Application for Works Approval

Works Approval Number W6910/2024/1

Works Approval Holder Water Corporation

Premises Northam Water Resource Recovery Facility
3 - 5 Colebatch Street and Crown Reserve 25729
Burlong WA 6401

Figure 4: Site plan of the proposed works at the Secondary Treatment Site
Works Approval: W6910/2024/1

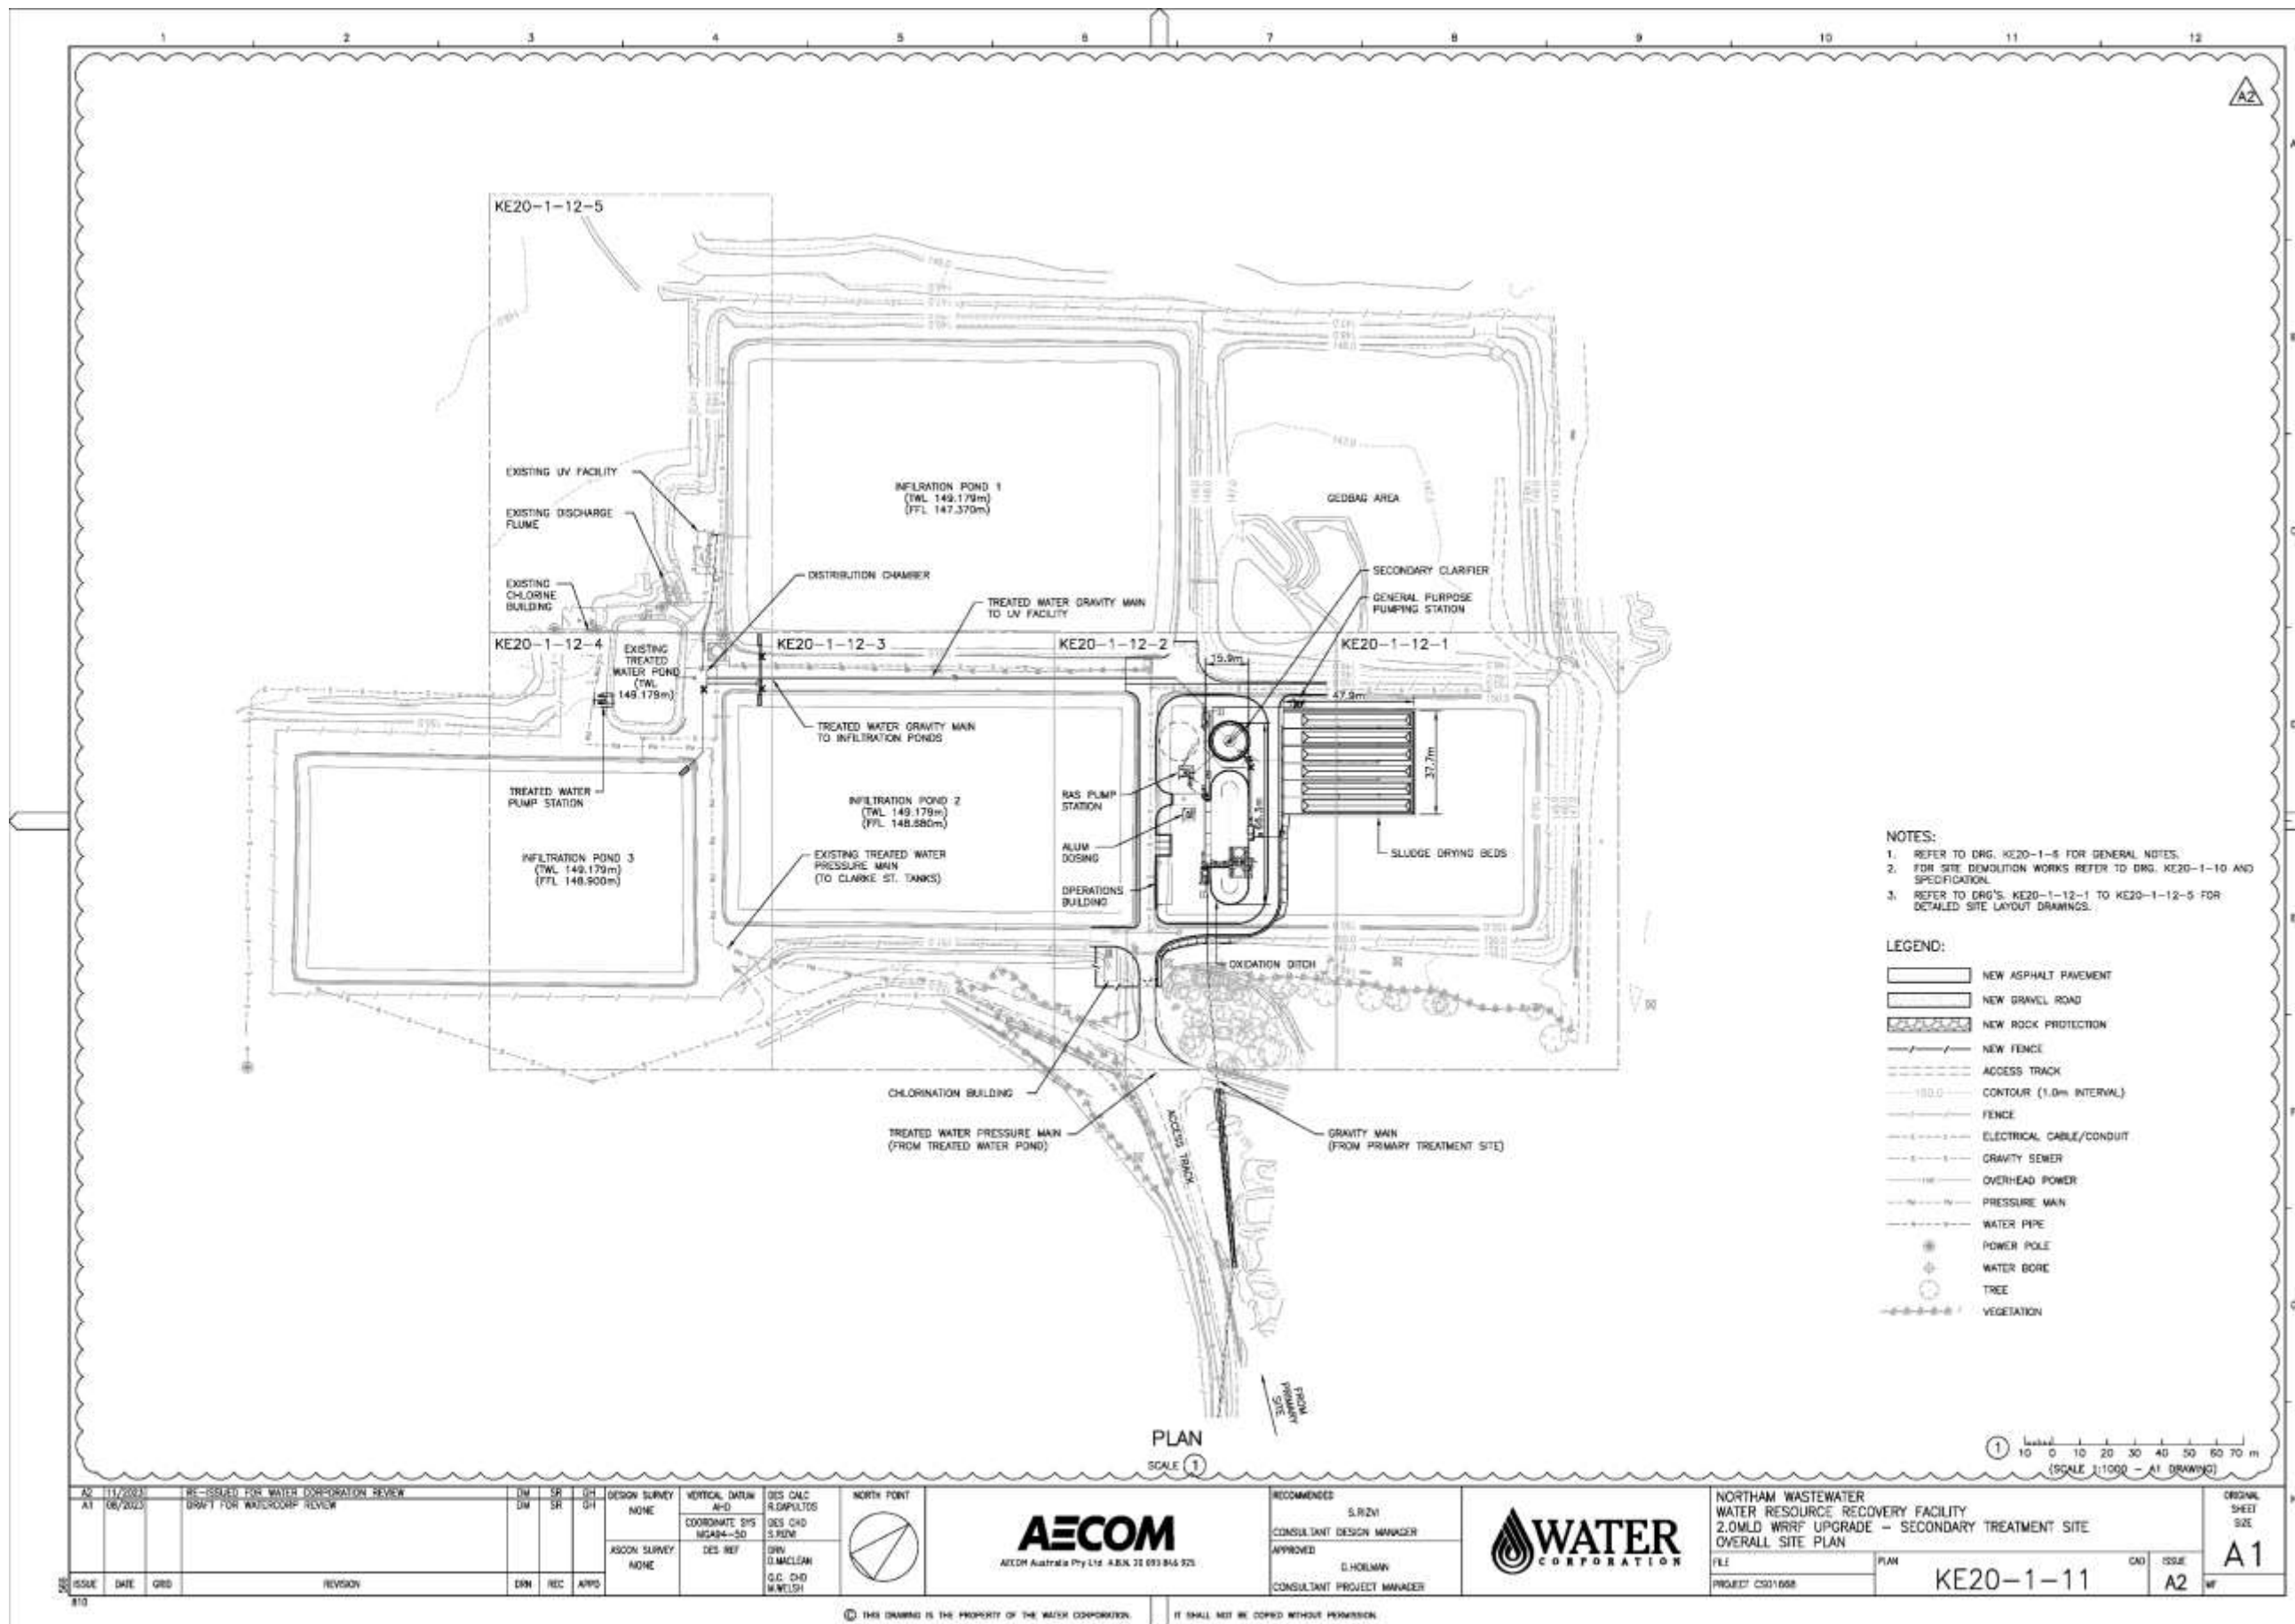
Condition 9 Table 4: Item 1	Change the discharge point location for line item 1 to "As shown in Figure 4". Correct typo: Clarke St.	Table revised. Typo corrected.
Condition 10 Table 5: Item 1	<i>E. coli</i> limits for recycled water schemes are legislated through DoH recycled water scheme approvals. As such, there is no requirement to set the level on the WRRF licence. This also means if the DoH update the <i>E. coli</i> limit the licence does not have to be updated as well.	In consideration of a regulatory control being provided through the DoH recycled water scheme approval, the Delegated Officer has removed reference to the <10 cfu/100 mL <i>E. coli</i> limit.
Condition 10 Table 5: Item 5	Change the <i>E. coli</i> limit for discharge to ODA to 1,000 CFU/100 mL. As per the WA decision report for Discharge of treated sewage to the ODA and Avon River causing impact to human health (Table 11): "An <i>E. coli</i> concentration limit of < 1,000 cfu/100 mL was considered satisfactory to mitigate impacts for the	The Delegated Officer notes that the application proposes discharges to the ODA as having a pathogen indicator level of less than 150 cfu/100 mL. This was the primary consideration in determining the risk rating for impacts to human health for recreational users of the Avon River. The applicant further clarified that <i>E. coli</i> concentrations being <150 cfu/100 mL was an error in the application documents and the
